# UNITED STATES PATENT AND TRADEMARK OFFICE

10/563,338

Louis Lagler

<b>Office Action Summary</b>	<b>Application No.</b> 10/563,338	<b>Applicant(s)</b> LAGLER, LOUIS	
	<b>Examiner</b> ANDREW T. KIRSCH	<b>Art Unit</b> 3781

Fig. 1 of US Patent No. 5,148,912 (Nozawa hereinafter)

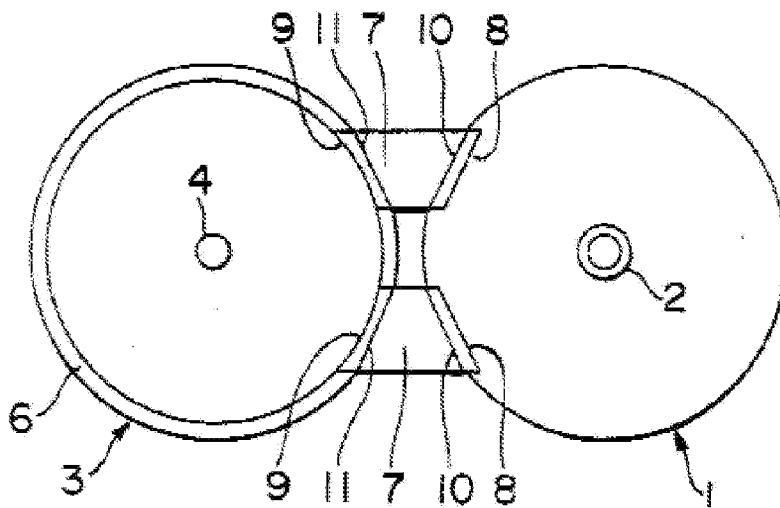
5. In re Claim 1, with reference to Fig. 1 and Fig. 4 above, Nozawa discloses: A closure moulded in closed position with

- a body (1) comprising fixing (col. 7, lines 5-7) means to fix the closure on a neck of a bottle, and

- a lid (3), comprising a sealing mean (4) to seal an orifice (2) of the bottle,
  - a snap hinge comprising a first and a second trapezoid element (7) and a first and second pair of film hinges (10, 11 ) each pair defining a first and a second plane (Fig. 4), the first and the second pair of film hinges (10, 11) connecting the first and the second trapezoid element (7) to the lid (3) and to the body (1), whereby the first and the second plane are arranged substantially parallel to an axis A (Fig. 4) of the closure.
6. Nozawa does not disclose that the body and the lid are separated by a circumferential gap.

11. In re Claim 5, with reference to Fig. 1 and Fig. 4 above, Nozawa discloses that that the film hinges (10, 11) are defined by a plane on the inside of the closure and the outside of the film hinges (10, 11) is defined by two flat boundary planes, arranged at an angle each other, and a cylindrical boundary surface having a radius. It is implicit that the boundary planes of the film hinges be at angle to each and have a cylindrical boundary surface otherwise the closure would not open.

12. In re Claim 6, with reference to Fig. 1 and Fig. 4 above, Nozawa discloses that the trapezoid elements (7) are spaced apart by a cutout.

**Fig. 5 of US Patent No. 6,041,477 (Rentsch et al. hereinafter)**

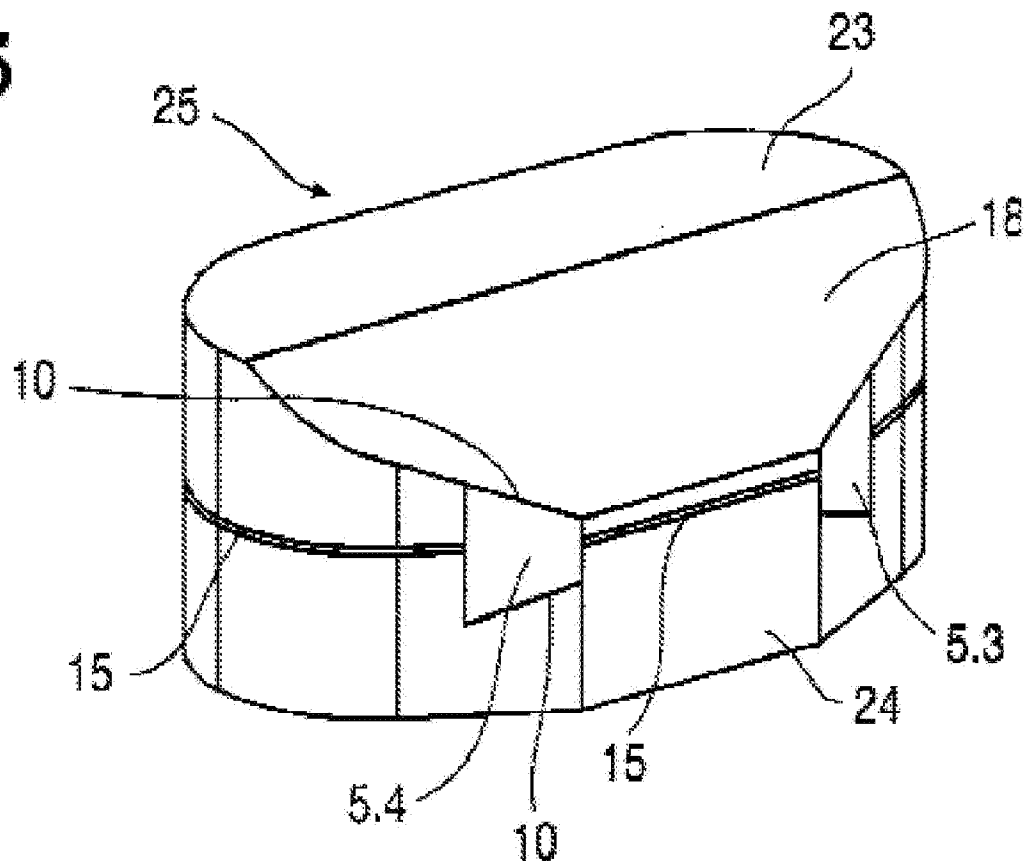
7. However, with reference to Fig. 5 above, Rentsch et al. discloses a closure whereby the body (24) and the lid (23) are separated from each other by a circumferential gap (15).

8. Thus it would have been obvious to one having ordinary skill in the pertinent art at the time the invention was made to have modified the closure of Nozawa to have a circumferential gap as taught by Rentsch et al. in order to achieve the predictable result of separating the body from the lid.

Fig. 7 of Rentsch et al.

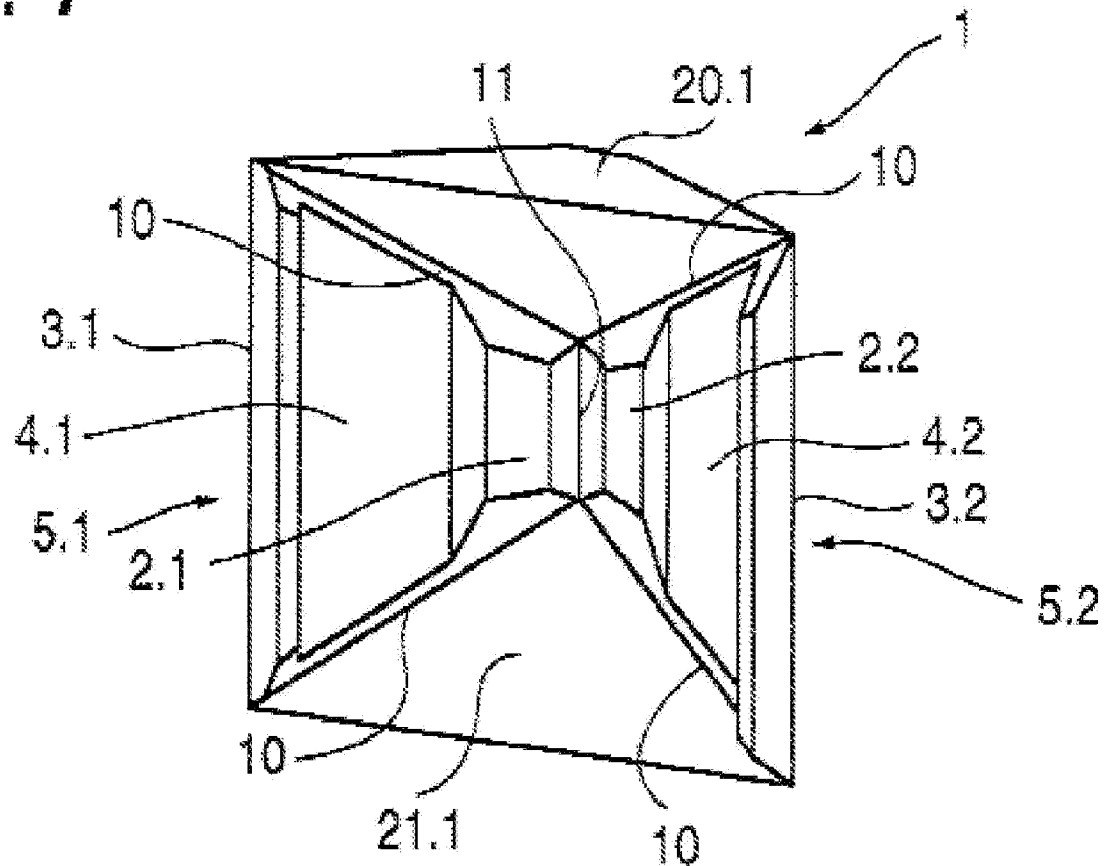
13. In re Claim 7, with reference to Fig. 7 above, Rentsch et al. discloses that the trapezoid elements (5.1, 5.2) are connected by a thin film hinge along a shorter edge (11).

**FIG.6**

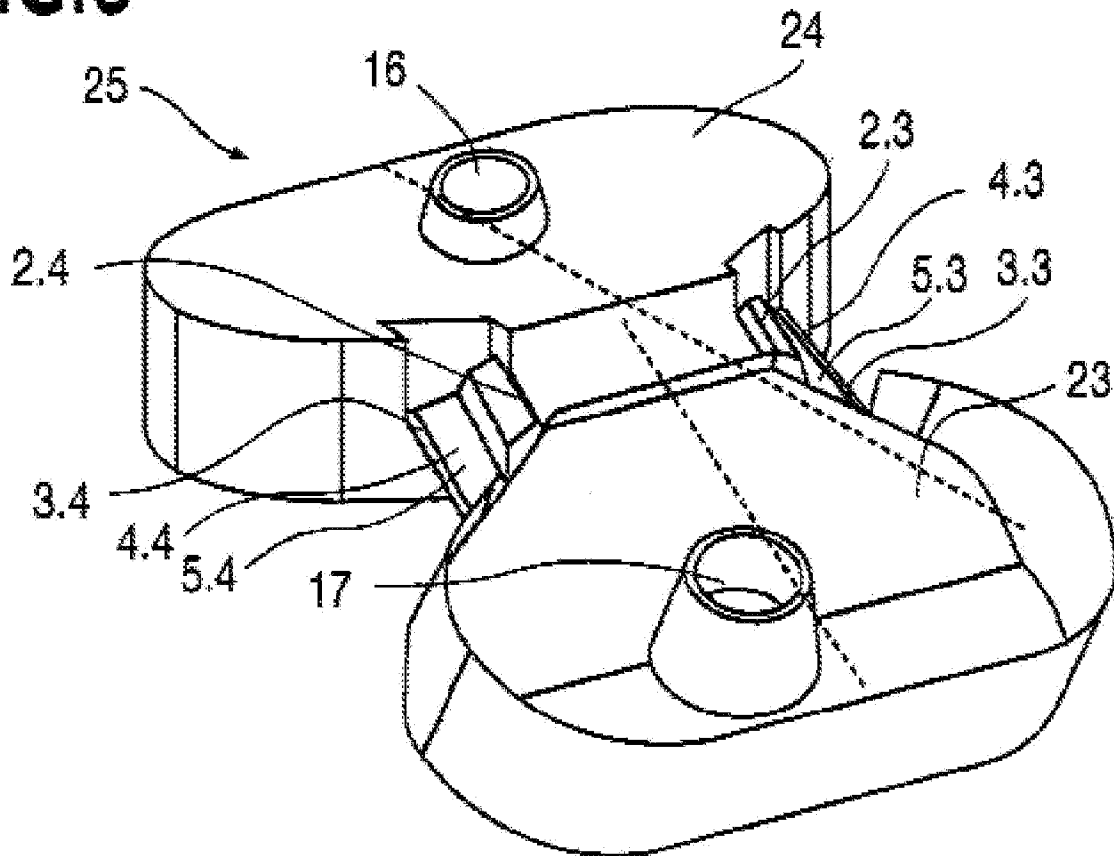
14. In re Claim 9, with reference to Fig. 6 above, Rentsch et al. discloses that the body (24) and lid (23) are in the open position spaced a distance  $s$  apart, whereby distance  $s$  is equal to 50% to 90% of the shorter edge of the trapezoid element (5.4, 5.3). In order for  $s$  to be 50% to 90% of the shorter edge of the trapezoid  $\alpha$  must be between  $120^\circ$  and  $154^\circ$  or between  $206^\circ$  and  $240^\circ$ . Rentsch et al. discloses that the closure is capable of angles greater than  $180^\circ$ . Thus, the closure disclosed by Rentsch et al. can be in either range of angles when in the open position.

**Fig. 3 of US Patent Application Publication No. 2002/0079282A1 (Harrold et al. hereinafter)**

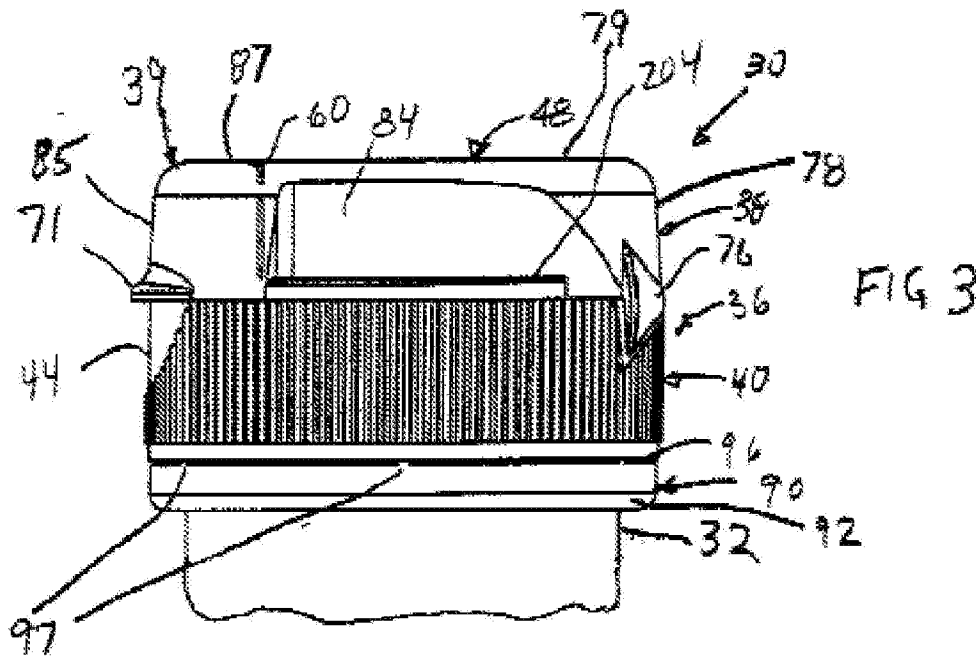
17. However, with reference to Fig. 3 above, Harrold et al. discloses tamper evidence means (90).

18. Thus, it would have been obvious to one having ordinary skill in the pertinent art at the time the invention was made to have modified the closure disclosed by Nozawa in view of Rentsch et al. to have tamper evidence means as taught by Harrold et al. in order to achieve the predictable result of indicating if the closure had been tampered with.
